<b>APPLICATION NO.</b>	<a href="#">P17/V0134/RM</a>
<b>SITE</b>	The Bungalow, Townsend Grove, Wantage, OX12 0AZ
<b>PARISH</b>	GROVE
<b>PROPOSAL</b>	Reserved matters application following outline planning permission P16/V0527/O (which permitted 14 flats, access only approved) for appearance, landscaping, layout and scale (as amended by revised building design and layout plans received 21 April 2017, further revised by amended landscape details received 26 May 2017, and further amended by revised elevations and floor plans to reduce height of two storey wing received 30 May 2017)
<b>WARD MEMBER(S)</b>	Ben Mabbett Chris McCarthy
<b>APPLICANT OFFICER</b>	D Pink Investments Ltd. Lisa Kamali

- 1.10 An up to date site layout plan (198-P1 Rev B) is included below. Extracts of the plans are attached at **Appendix 1**, and two views of the development are included at **Appendix 2**.

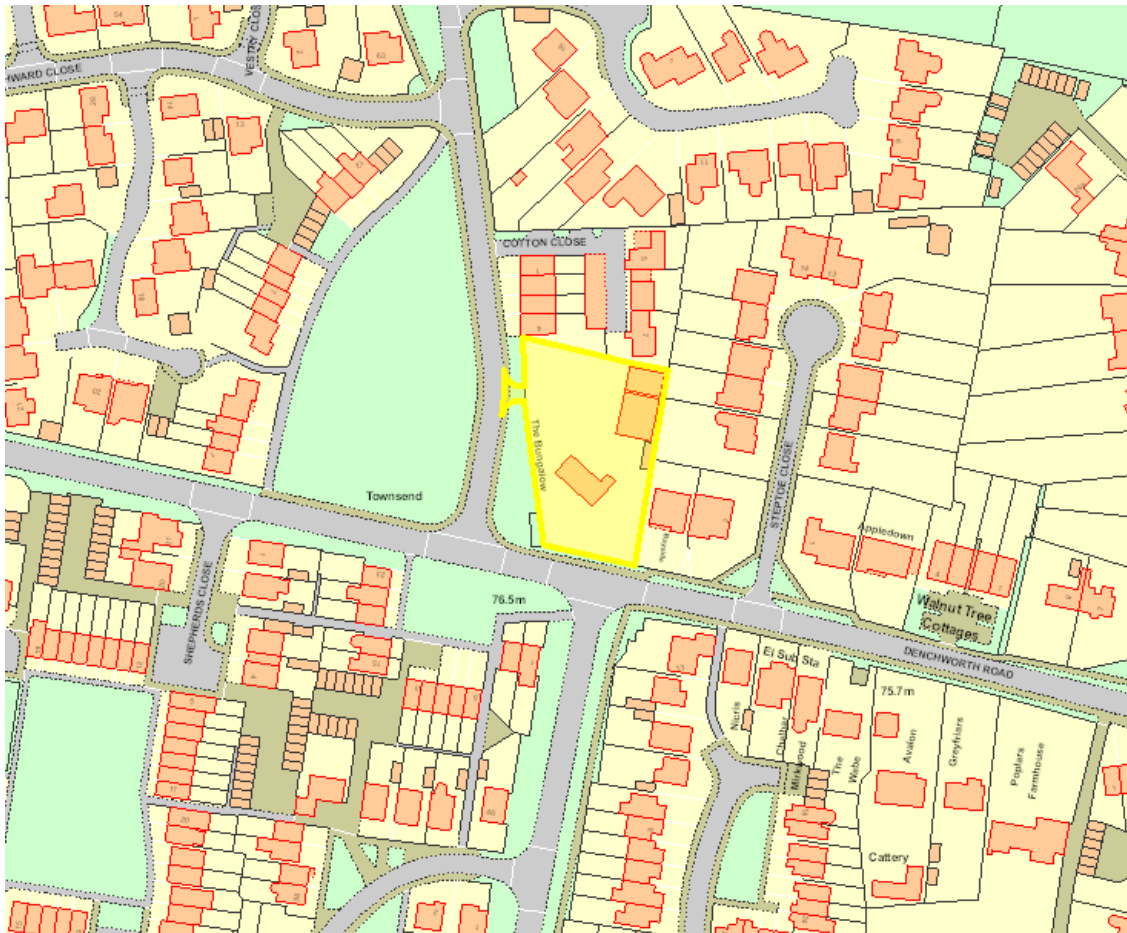
- Still have concerns about the removal of all the sites boundary vegetation and the proposed culverting the existing ditch. The current character of the area is the green boundary vegetation and trees, the resultant design would change the local character.

- The existing vegetation on the sites western boundary could be retained with the vegetation reduced in height to create a hedgerow to match the existing hedge along the southern site boundary.

- With regards to the rear parking the design needs to create a defined space for the residents to enjoy.
- Currently the layout shows large areas of grass which would be difficult to maintain such as along the sites northern boundary and does not provide amenity to the area.

5.36 Officers consider that the existing boundary vegetation and the ditch should be retained. The applicant responded to this by providing an amended site layout plan (198-P1 Rev B) which now shows boundary planting to be retained, managed and supplemented with new native planting, which is an acceptable response which addresses previous concerns. It was not considered necessary to re-consult on this revised plan which only shows a minor change to labelling.
